Mark Harding – Exhibit 828
Data Request Harding 36A
File No. EA-2024-0302

Ameren Transmission Company of Illinois
Response to Intervenor's Data Request - Harding
EA-2024-0302

Application of ATXI for a Certificate of Convenience and Necessity under Section 393.170.1,
RSMo. relating to Transmission Investments in Northwest and Northeast Missouri
Dated Submitted: September 22, 2025

No.: Harding 36A

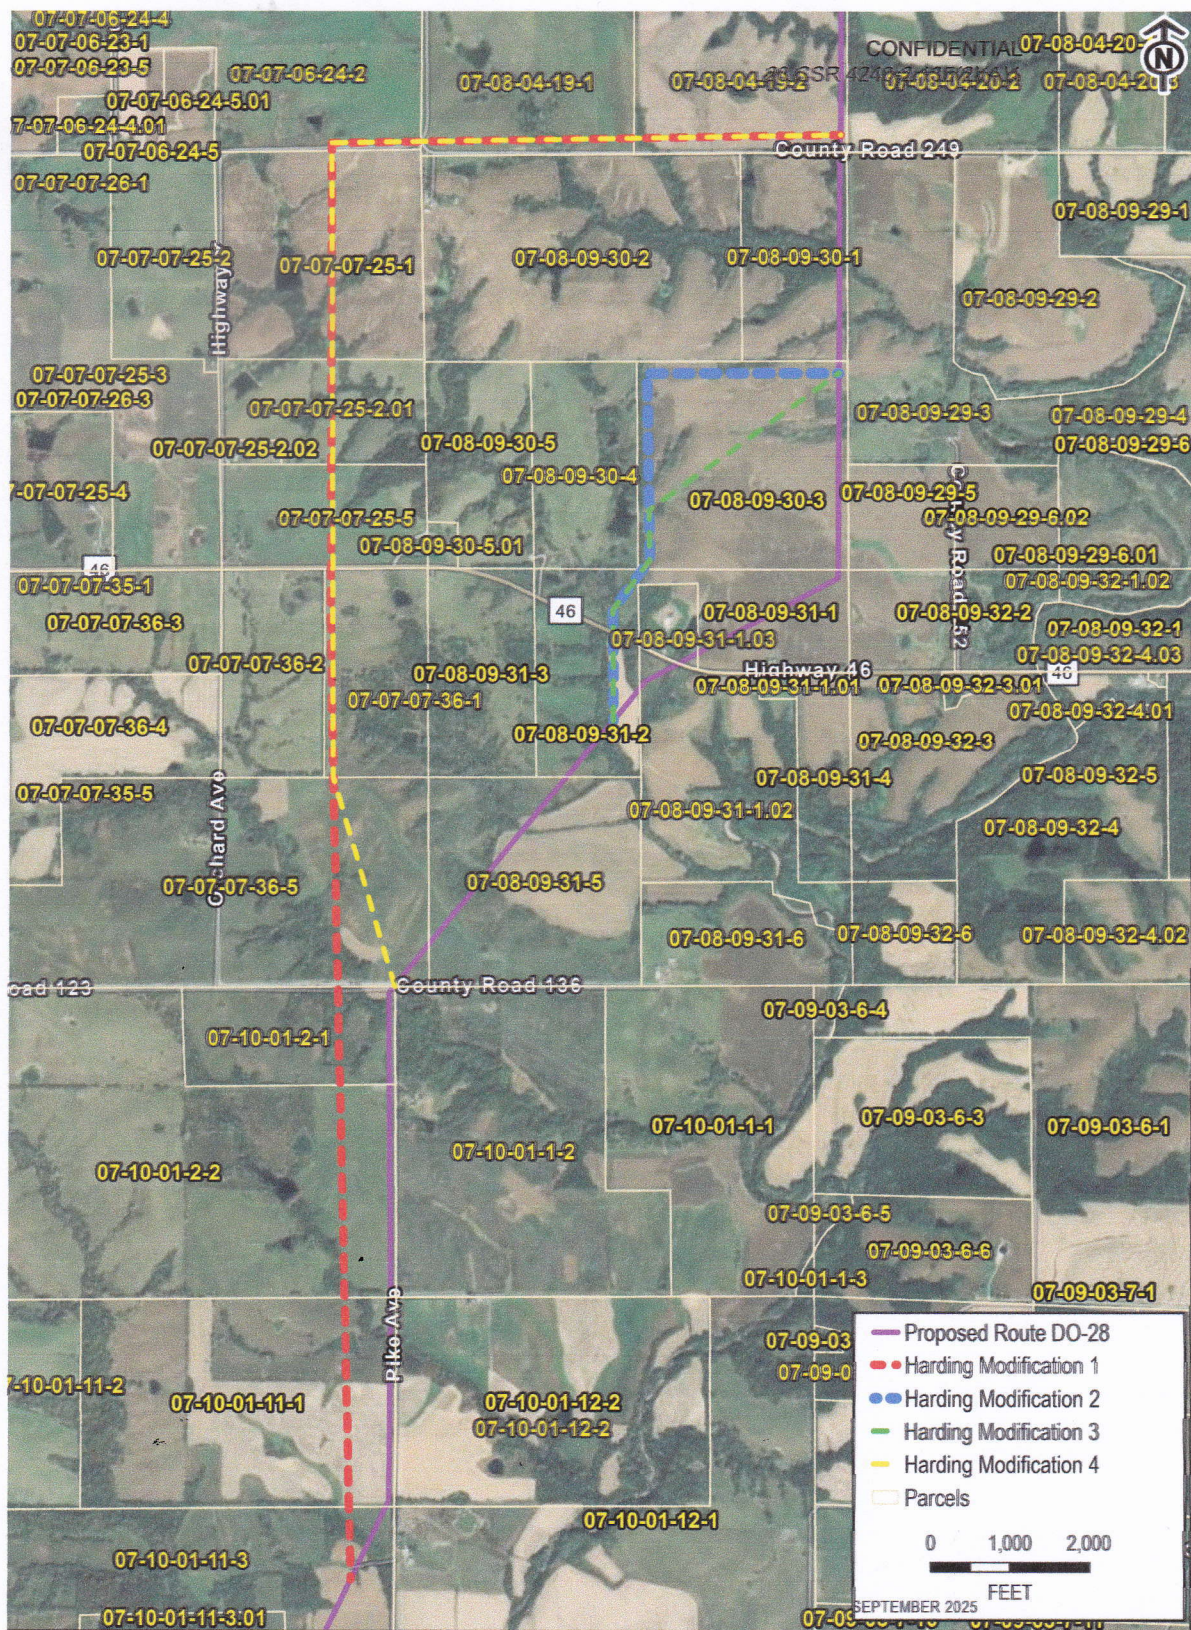
A: What is the distance in linear feet from the [REDACTED] residence (residence #4 in attachment "Structures.pdf") to the centerline of each of the following:

B: What is the distance in linear feet from the [REDACTED] residence (residence #3 in attachment "Structures.pdf") to the centerlines of each of the following:

C: What is the distance in linear feet from each of the [REDACTED] residences (residences #5 and #6 in attachment "Structures.pdf") to the centerline of the following:

ATXI understands the references to "MPSC 57.0 attach" to mean "MPSC 57.0 Attach 1 (CONFIDENTIAL)." ATXI's responses reflect this understanding. ATXI also notes that the structure labeled 6 appears to be a barn rather than a residence.

- A.1. The distance in linear feet from residence #4 to the centerline of Harding Modification 2 is approximately 622 feet.
- A.2. The distance in linear feet from residence #4 to the centerline of Harding Modification 3 is approximately 622 feet.
- B.1. The distance in linear feet from residence #3 to the centerline of Harding Modification 2 is approximately 1,135 feet.
- B.2. The distance in linear feet from residence #3 to the centerline of Harding Modification 3 is approximately 1,135 feet.
- C.1. The distance in linear feet from structure #5 to the centerline of DO28 is approximately 750 feet. The distance in linear feet from structure #6 to the centerline of DO28 is approximately 740 feet.
